Subject: UNIVERSITY VILLAGE AT LAKE DESIGN

ALTERNATE BUILDING/OPEN SPACE DESIGN
UNIVERSITY VILLAGE AT LAKE
JUNE 2017

UNIVERSITY VILLAGE AT LAKE
 AMENDED BATH ACCESS DESIGN
 WITH ACCESS FROM COMMON
 LIVING AREA/HALLWAY
 JUNE 2017 M. BELLUOMINI

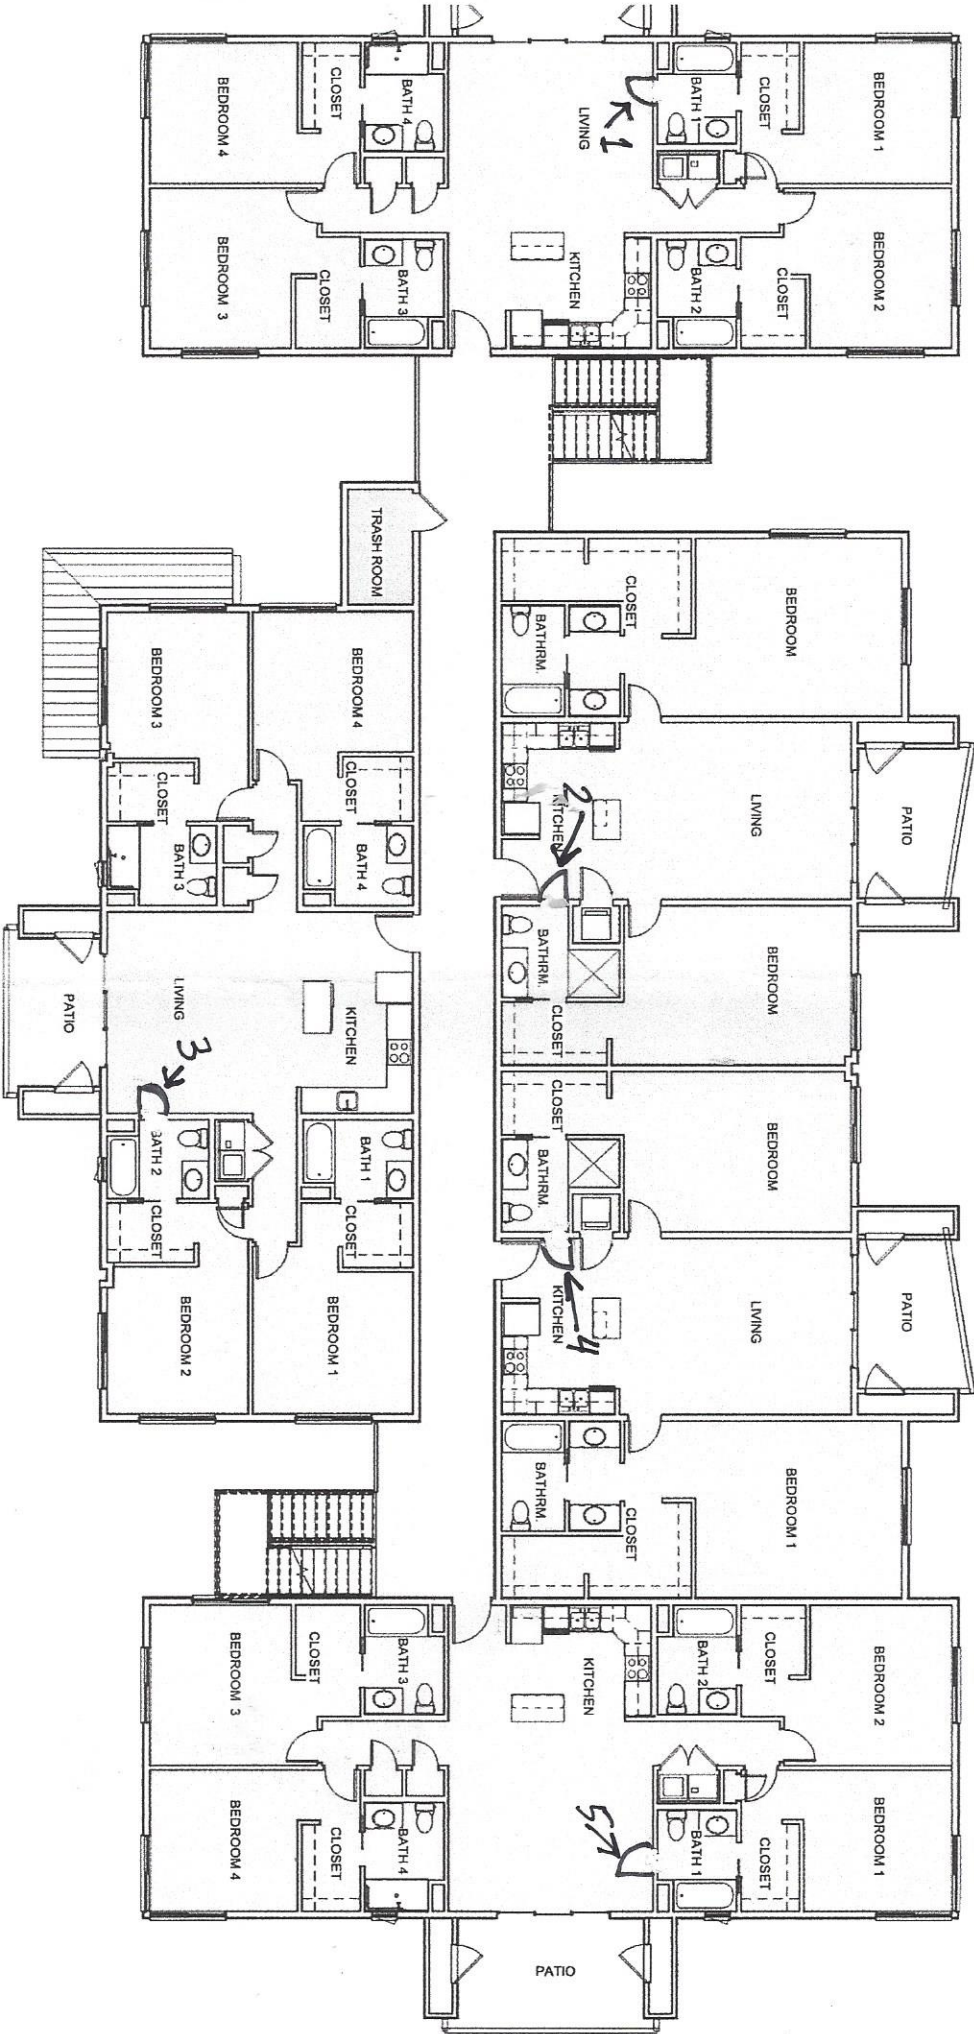
The first change is to achieve clustering of apartment buildings into groups that have an adjacent open space that seems like it belongs to those apartments. This improve security, safety, and development of neighbor relations that are better for residents. The current design north of the club house looks like "human filing cabinets". Buildings in a row with no relation to an outdoor space, focal point, or gathering place near to and unique to those buildings. The alternate design incorporates courtyards A, B, & C in addition to the pool clubhouse gathering area. It also relocates the basketball court so it is surrounded by apartments rather than at the far end of the complex away from most apartments that might use it. This is in keeping with the new zoning ordinance design guidelines for apartments. The developer should be complimented for following the guideline to provide every unit with a balcony. More improvements can be made.

The second change is to improve the solar exposure so that balconies and windowed rooms have good sunlight without glare and excess heat gain. In the original design seven (7) of the apartment buildings face east-west, so that they have glaring hot sun in the afternoon or morning coming in at a low angle. This makes balconies less useable. In the design alternative only three of the buildings face east-west while the other 12 face generally north-south. North-south facing windows and balconies receive sunlight but in the summer the angle of the sun is high so roof overhangs create shade successfully. In the winter when the sun is low in the sky the south facing units receive sunlight during a cold and dark time of the year, thereby improving the living environment.
